49 CFR Part 572

Anthropomorphic Test Devices; Hybrid III 6-Year-Old Child Test Dummy, Hybrid III 6-Year-Old Weighted Child Test Dummy

ACTION: Final rule.

Figure 1: Illustration of femur assembly

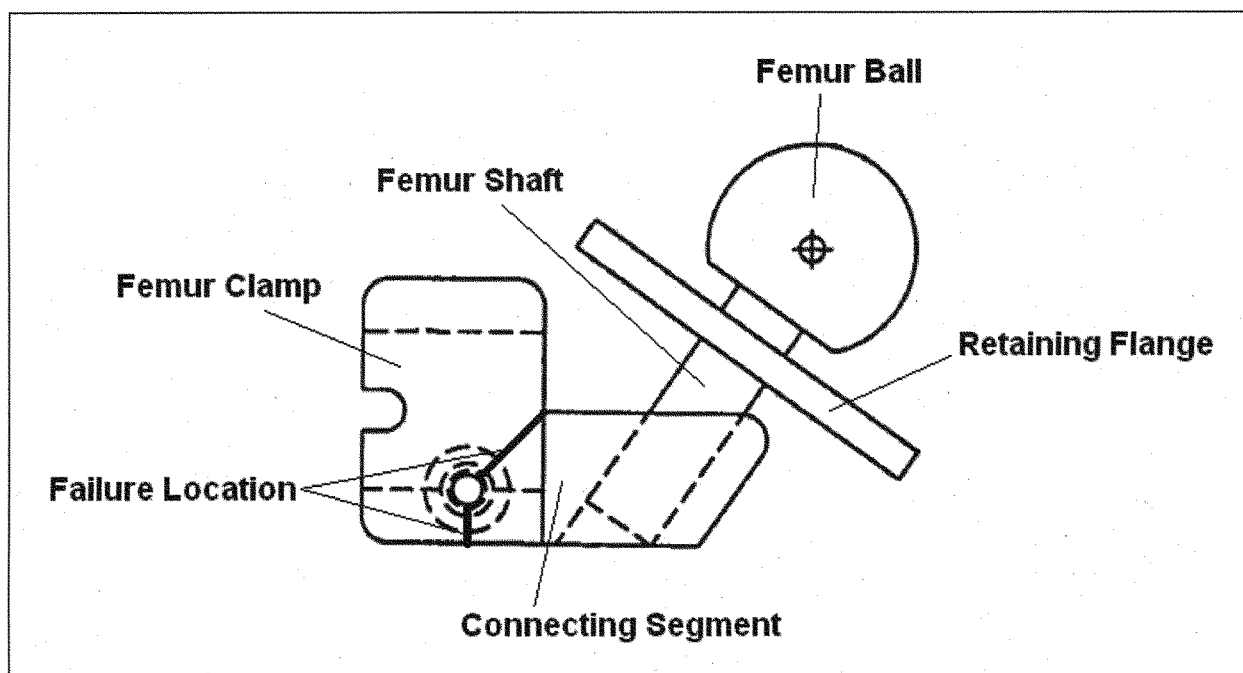
Failures of the HIII-6C femur appear to have initiated at a sharp corner between the femur clamp and connecting segment sections of the machined femur. The approximate location of the femur failure is depicted in Figure 1. The fracture was observed from this corner to the bolt hole within the femur clamp, at an angle of approximately 45°. The failure continued through the thin section of material directly beneath the bolt hole,

The modification made today to improve the femur’s durability increases the strength and durability of the femur assembly by fabricating the machined femur and shaft from 4340 steel, which has a higher yield strength than the original material, Aluminum Bronze C-624 AMC0-18, while keeping the ball and retaining flange as the original aluminum bronze material. A ¼-inch (6.35 mm) fillet is added between the

femur clamp and the connecting segment to eliminate stress risers that were present on the original femur, and a portion of the connecting segment

To implement this change in femur design and material, the following changes are made to the materials describing the HIII-6C in 49 CFR part 572. Drawings 127-3017-1&-2, “6 YR H3-FEMUR MACHINED” is replaced with drawings 127-3017-1S&-2S, which show the new machined femur.³ The femur assembly drawings (127-3016-1&-2) are also replaced due to the new femur design, with new part numbers 127-3016-1S&-2S. Higher assembly drawings including 127-3000, “LOWER TORSO ASSEMBLY” and the complete assembly drawings (127-0000) are amended to show the modified part. These revisions are noted on drawing SA572-127DRL-2. The PADI is also updated so that it shows the new machined femur in figures, and reports the proper lower torso assembly and total weight for the dummy. Finally, the part numbers for the machined femur and the femur assembly are changed in the Parts/Drawings list, along with the revision letters for higher assembly drawings, as appropriate.

Figure 7: Portions of the HIII-6C abdomen insert drawing

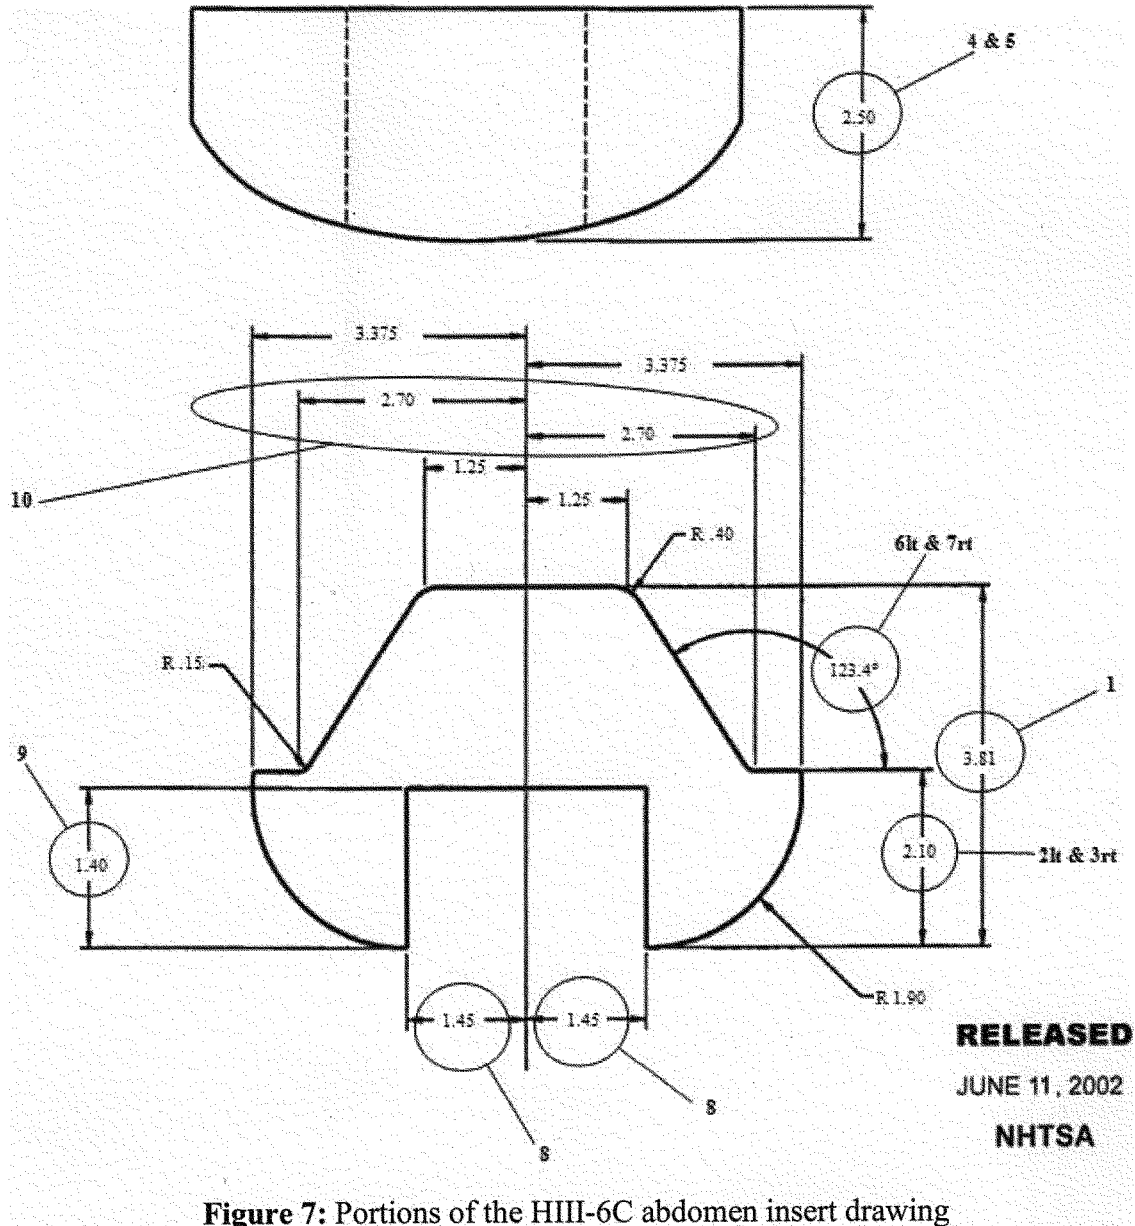
This final rule changes Drawing No. 127–8210 of the HIII–6C drawing package, which depicts the abdominal insert for the dummy. It makes a similar change to the HIII–6CW drawing package.⁸ This change responds to a petition from FTSS and Denton. Both manufacturers sought to revise the abdomen insert drawing to match the part mold dimensions.

In the NPRM, the agency granted the request but proposed to revise the drawing of the abdominal insert based on dimensions of actual abdominal inserts, rather than dimensions of the mold for the inserts. Nearly all changes were in agreement with the petitioners’ mold-based dimensions.

Table 4 shows the changes this final rule makes to key abdomen dimensions. “Fig. Ref” numbers in the table refer to Figure 7, which shows the original dimensions.

Description	Fig. ref.	Adopted spec.
Overall height (in.)	1	3.81 +/- .20
Ledge height (in.)	2lt	1.53 +/- .20

Description	Fig. ref.	Adopted spec.
Depth excl. plug (in.)	3rt	1.53 +/- .20
Depth incl. plug (in.)	4	2.80 +/- .20
Taper angle of cone (degrees)	5	2.80 +/- .20
	6lt	121/129
	7rt	121/129
Notch Half Width (in.)	8	1.50 +/- .20
Notch Depth (in.)	9	1.40 +/- .20
Width Bottom of Cone (in.)	10	5.40 +/- .40
